**SAND CREEK - CENTER TRIBUTARY
CHANNEL ANALYSIS REPORT
FOR
SOLACE APARTMENTS**

**May 1, 2020
Project No. 25174.00**

**Prepared By:
JR Engineering, LLC
5475 Tech Center Drive
Colorado Springs, CO 80919
719-593-2593**

PCD File NO. SP201

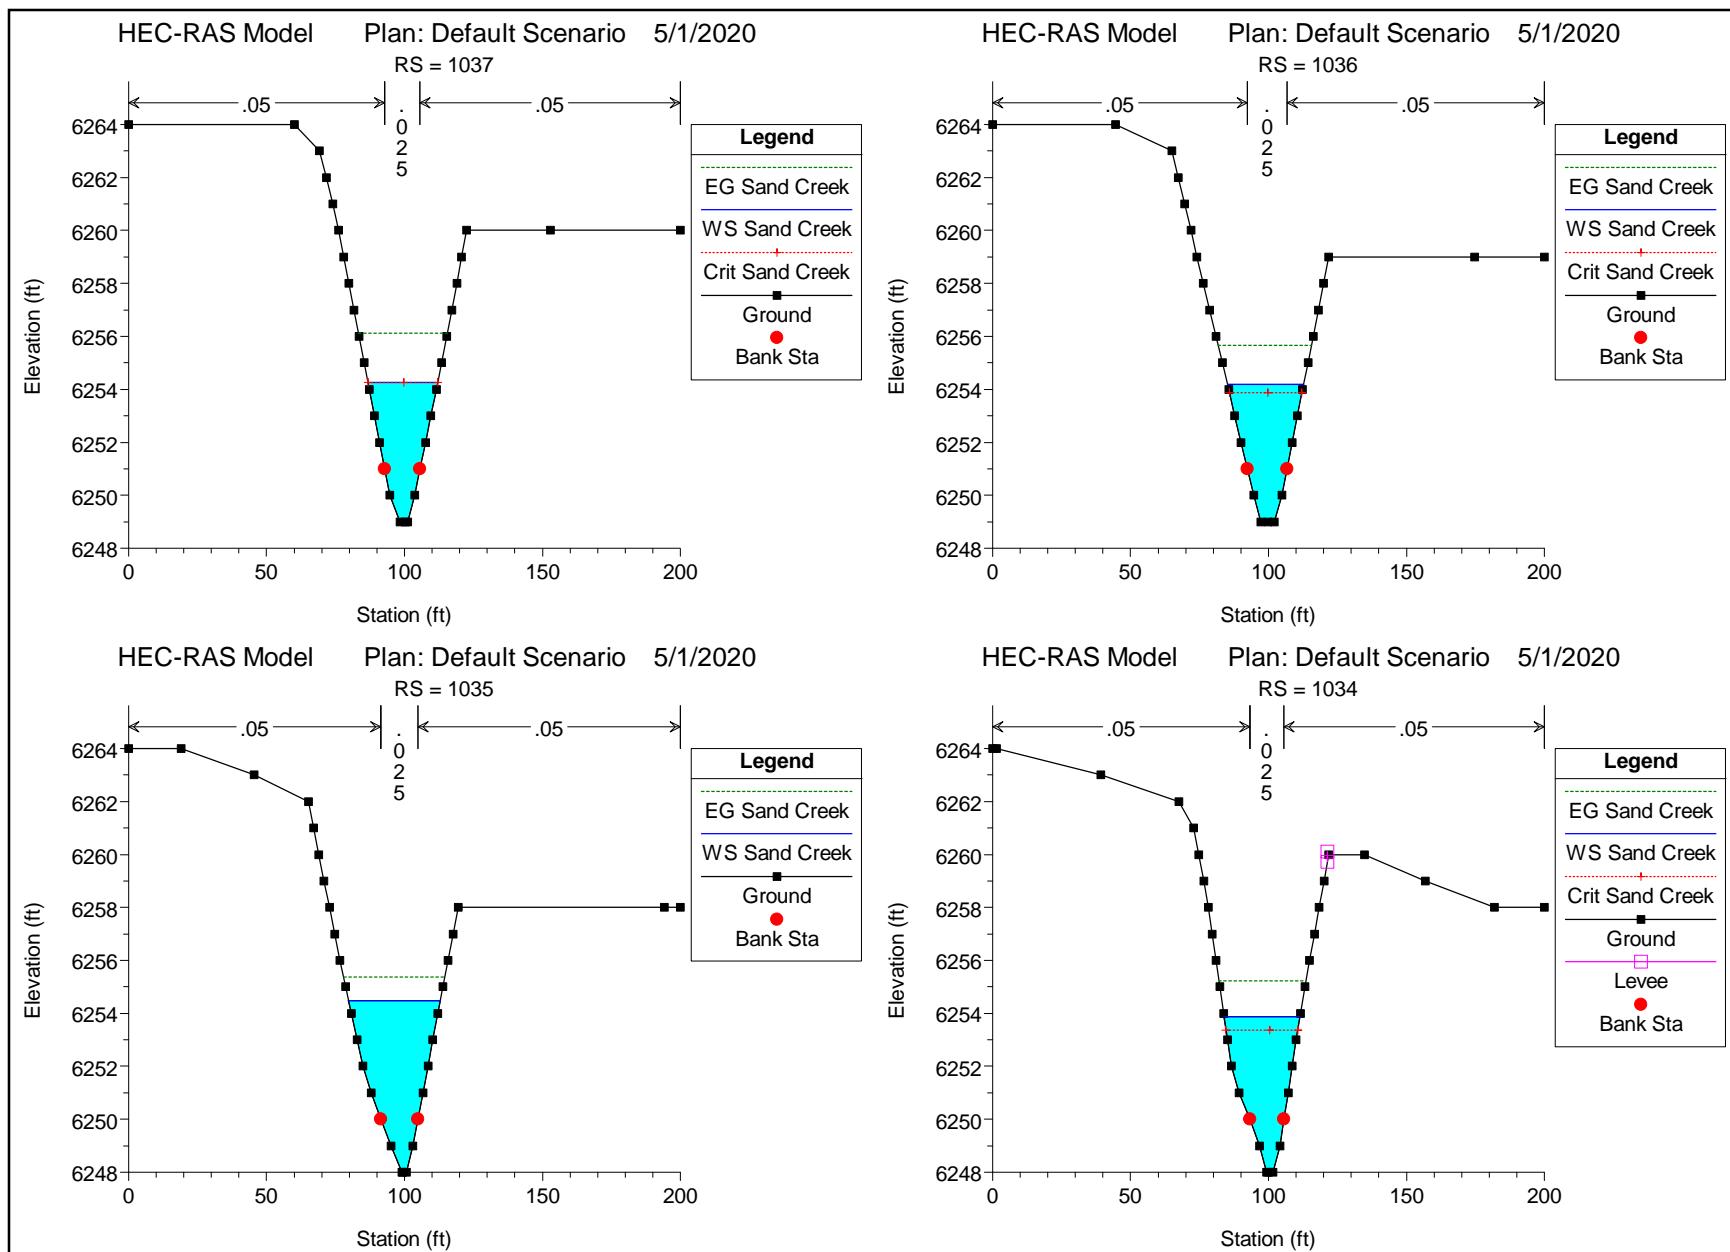
Extend the cross section further out. The hydraulics does not appear to provide an accurate representation of the existing conditions/extend of the 100yr flow
